## Operation Permit

PROPERTY LOCATION: 53 Priming way, Angkor

SUBDIVISION Tobacco Rd LOT # 77

Tobacco Road  
Lot 77  
4 BR  
Harnett County

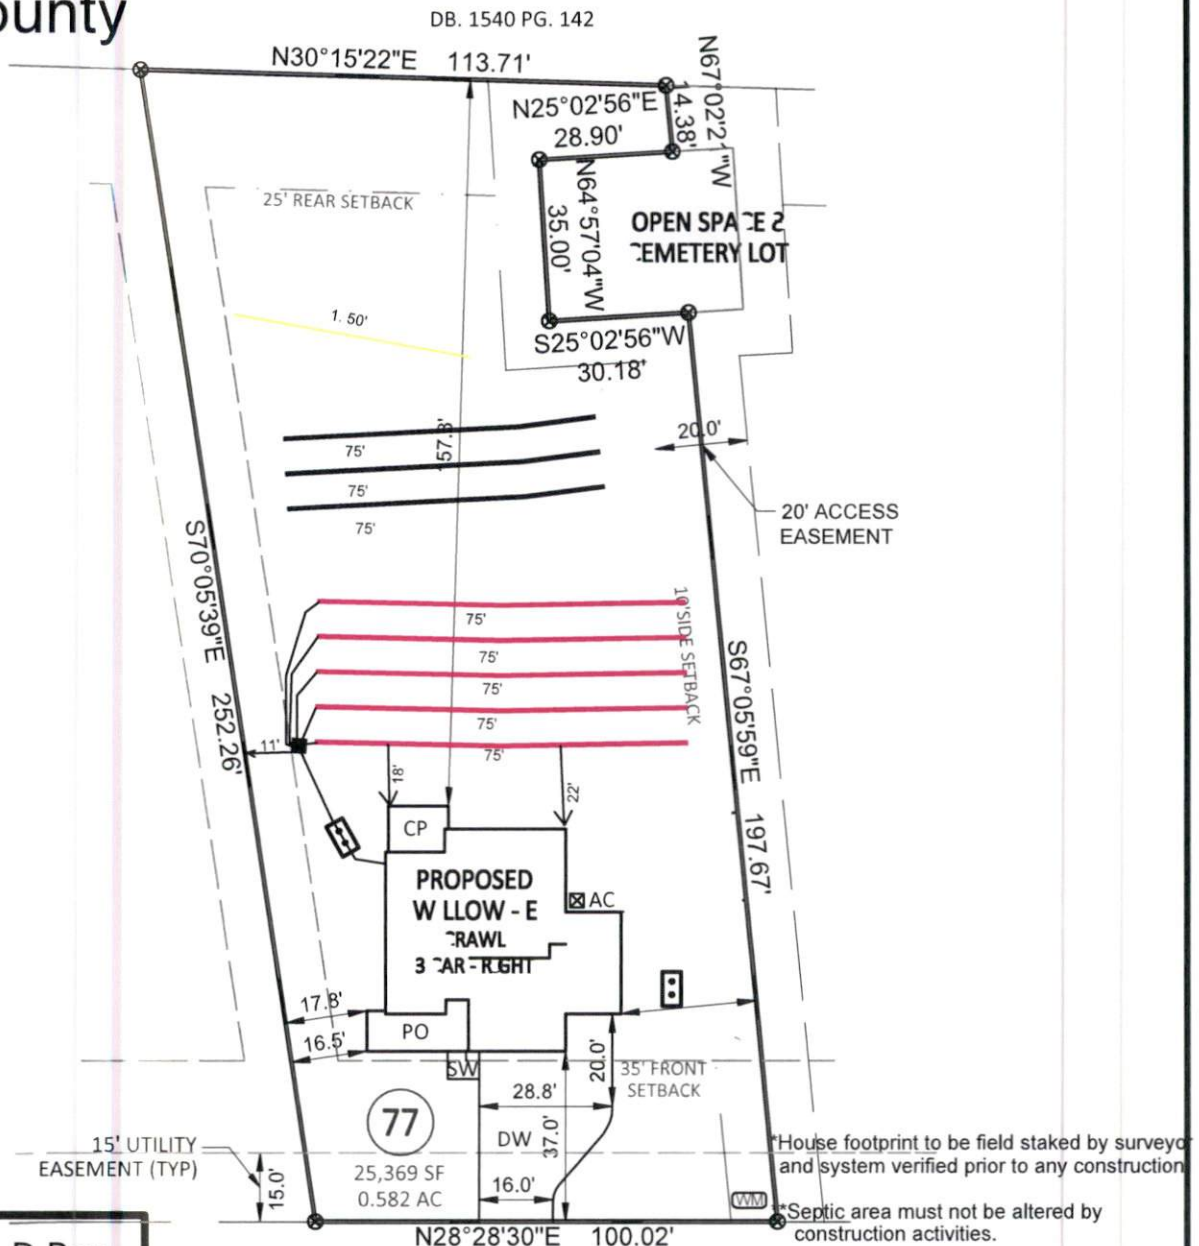
\*As Built Revision - Approved by Alex Adams  
\*Initial system changed to gravity and  
Repair will be 50% reduction

INITIAL: Gravity to D-Box  
Lines 1-5 (375')  
Accepted Status

REPAIR:  
Lines 6-9 (275')  
PPBPS - 50% reduction  
Pressure Manifold
